DELEGATED DECISIONS BY CABINET MEMBER FOR TRANSPORT MANAGEMENT

25 APRIL 2024

EAST CARTERTON: UPAVON WAY, CARTERTON ROAD, MARSH WAY/NORTON WAY & BRIZE NORTON ROAD - PROPOSED SHARED FOOTWAY & CYCLEWAYS

Report by Corporate Director, Environment and Place

BLOOR HOMES
 Drawing No. WE088-EN-1000-A0

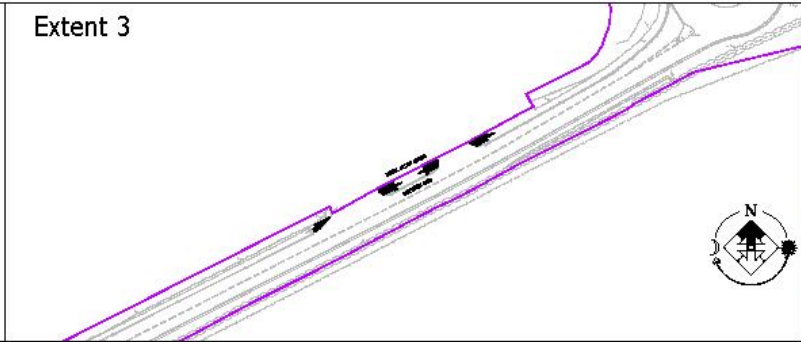
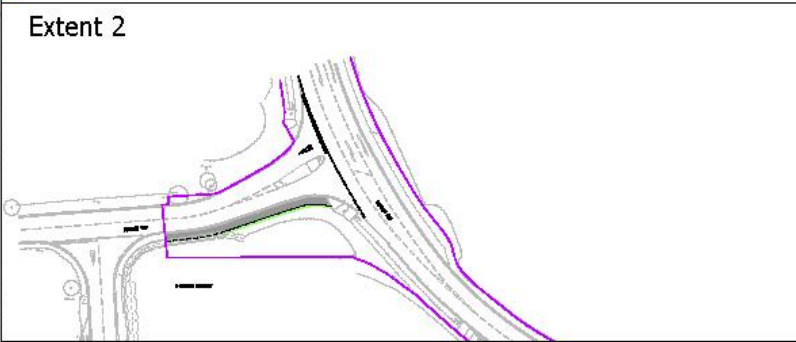
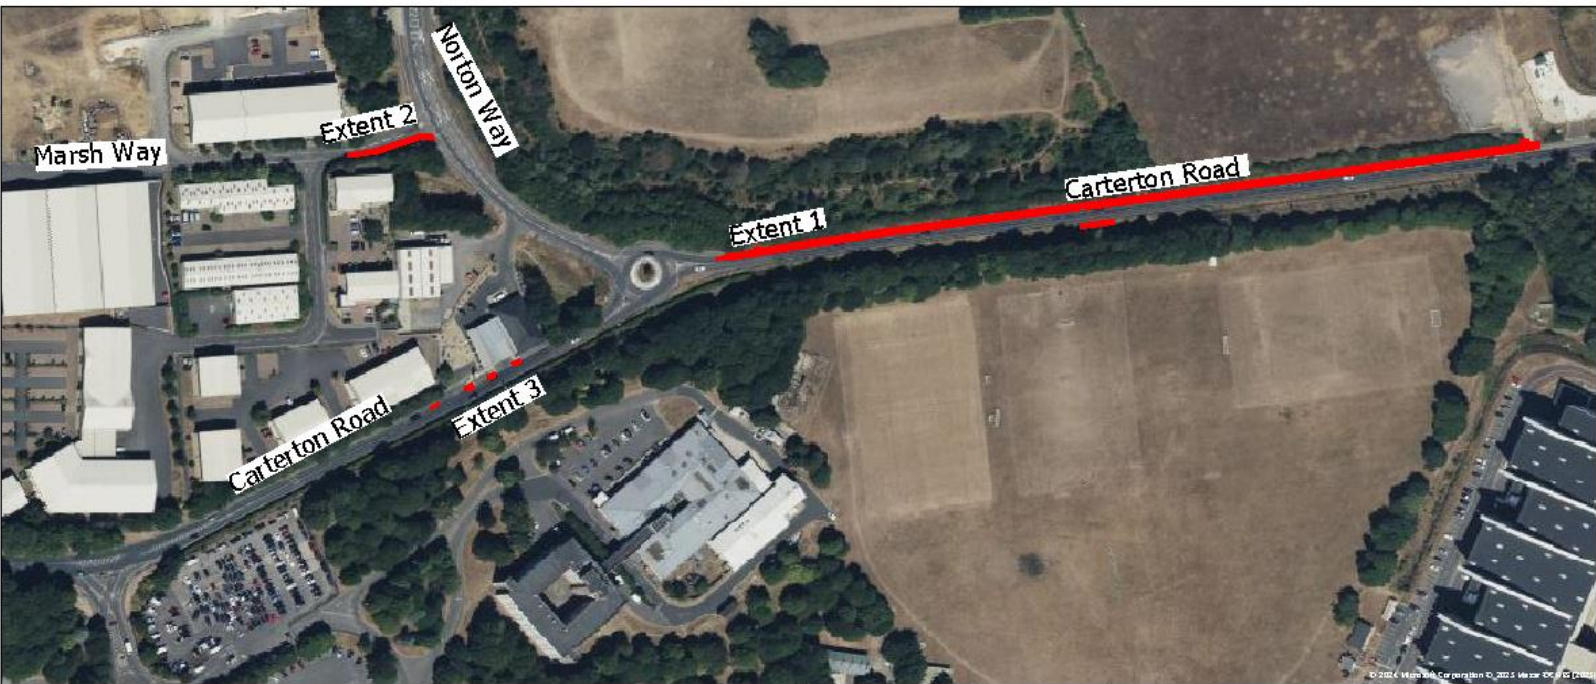
<p>(14) Local resident, (Carterton, Brize Norton Road)</p>	<p>Concerns</p> <p>(1) Crossing Norton Way from the east, there is a long right bend and blind to your right is a 40mph sign and sometimes you cannot hear approaching traffic from the right. The 30mph sign is at the roundabout and is hidden by trees, suggest moving the 30mph back 50mtrs and put in speed hump with warning signs of pedestrians. cyclists etc.</p> <p>(1A) Exiting from BP onto Carterton Road has to cross the shared path, who has right of way?.</p>

(2) The pedestrian crossing is fine but path to (3) is narrow

(3) This area needs a lot of care, 2 lanes in and 2 out of RAF station

(4) The path continues onto Brize Norton Road to Wycombe Way, no end of shared path sign.

(5) If the route from (4)-(6) which is the Aldi supermarket was a shared path you would have a fantastic route all the way from Brize Norton to three supermarkets, health centre, market town hall and everything else the town centre offers.

(8-8) Is your proposed route (blue line on map) ending on a blind left hand bend which i find dangerous because of eastbound overtaking traffic towards the roundabout.

10. Thames Valley Police expressed no objections to the proposals as advertised.
11. With regards to the safety concerns expressed about driveway visibility along the Brize Norton Road, Officers have confirmed that the 'Stage 2 Road Safety Audit' did not highlight any concerns around this particular issue.

Drawing No: WE088-EN-2000-A0

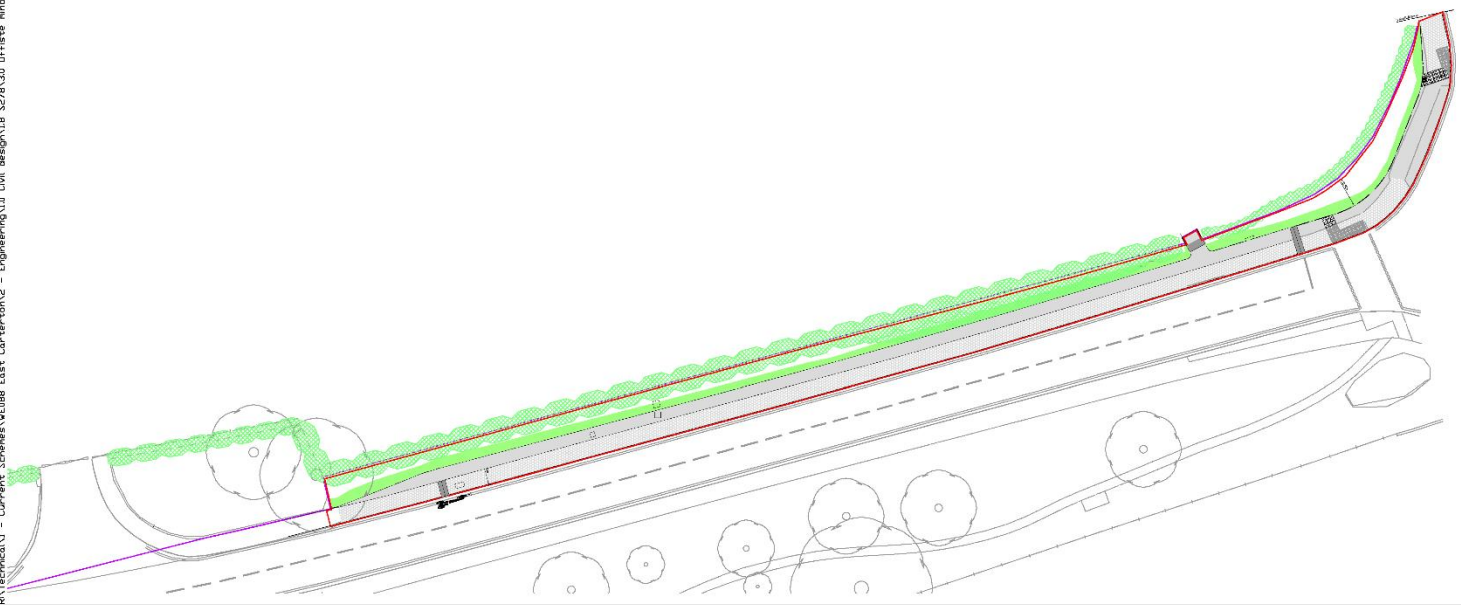
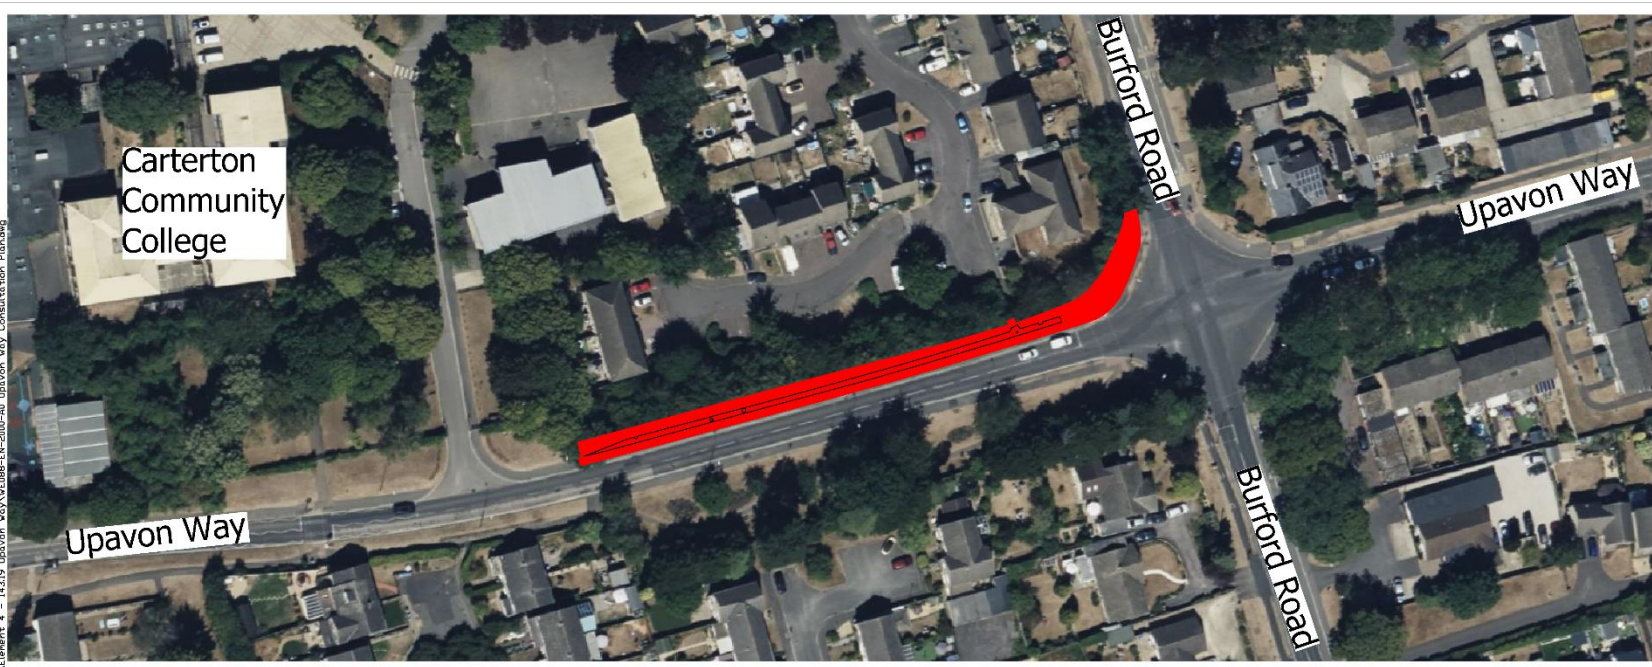
(9) Local resident, (Carterton, Cotswold Way)	<p>Upavon Way – Support Carterton Road – Support Marsh Way/Norton Way – Support Brize Norton Road – Support</p> <p>Safer for both cyclists and motorists- as the work is carried out can the footpath where the burford road/Upavon road meet by the lights be widened- it's a narrow busy footpath with the secondary school and the grass is being churned up as a result.</p>

13. Officers note that additional lengths of path were requested, however these fall outside of the scope of this specific project, and therefore are unable to be considered as part of these proposals.
